Permit #
B00149798

SITE SURVEY

SITE INSPECTION SHEET

PROPOSAL: LP installation - Submitted drawing incorrect

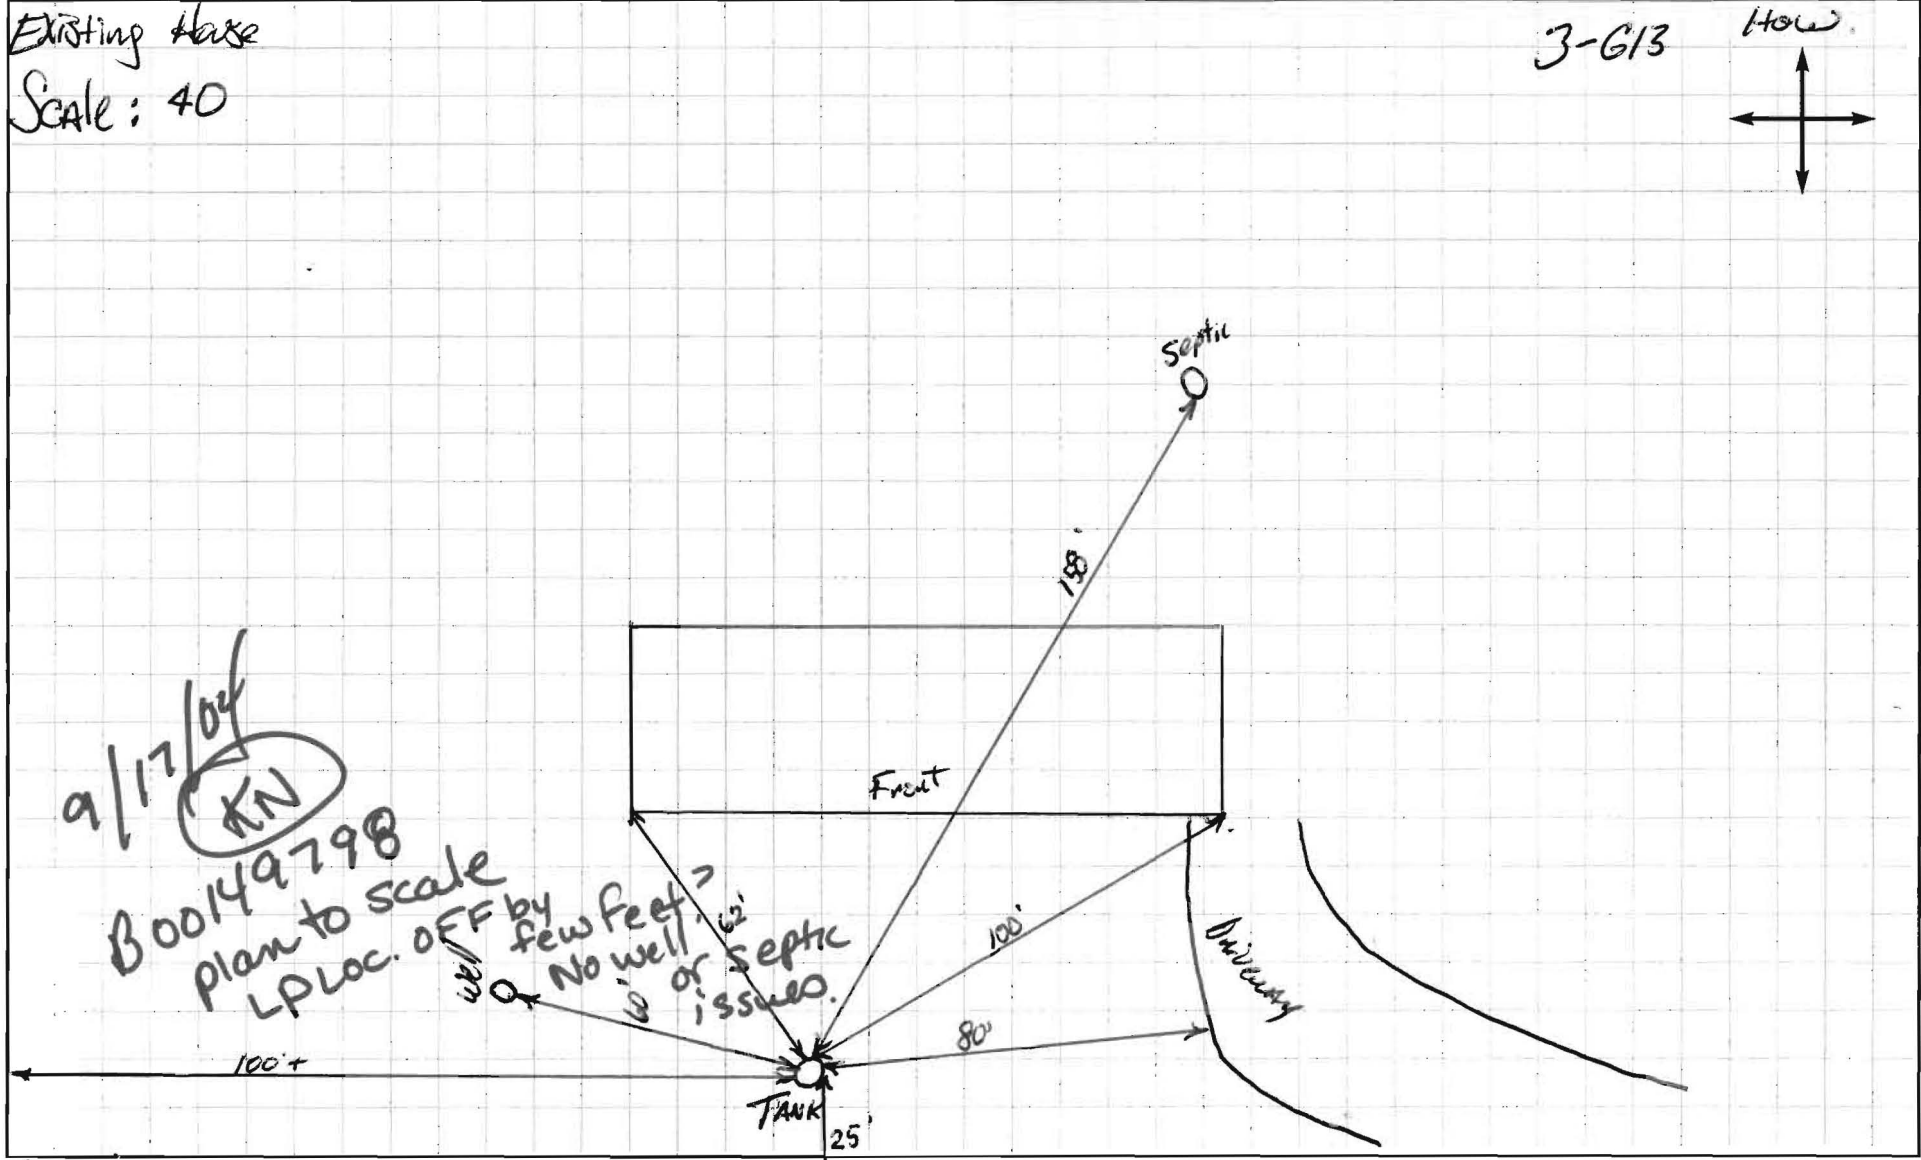
* BUILDING PERMIT NOT APPROVED - LP TANK ALREADY PLACED IN THE GROUND

LOCATION DIAGRAM

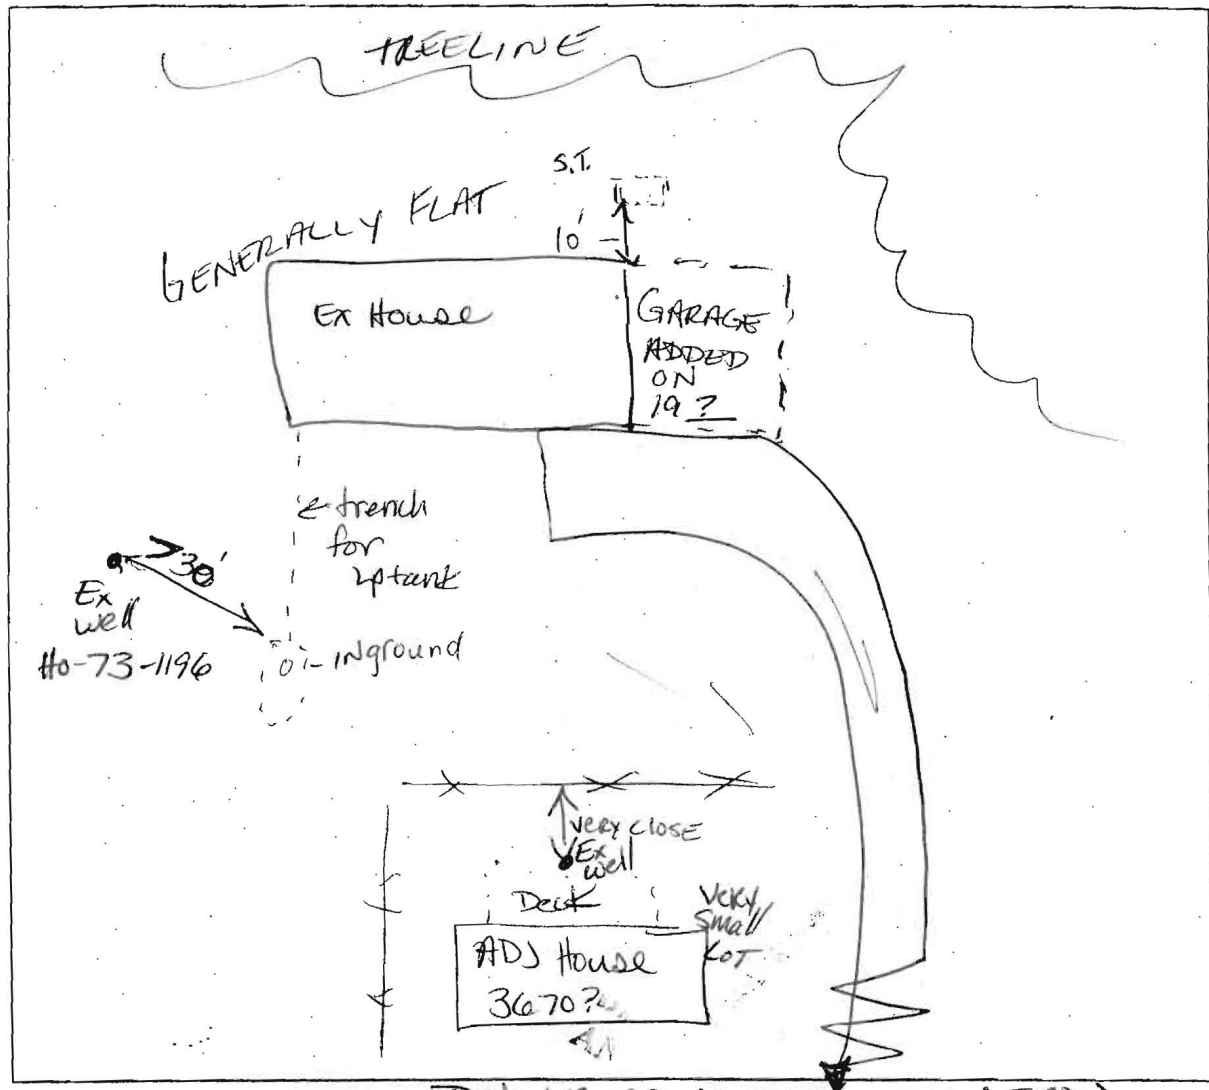
COMMENTS: 1976 septic installation notes appear accurate due to ground indentations. However, there aren't any cleanouts. LP tank already in ground but owner says not hooked up to electric yet. BPO0149798 wasn't signed
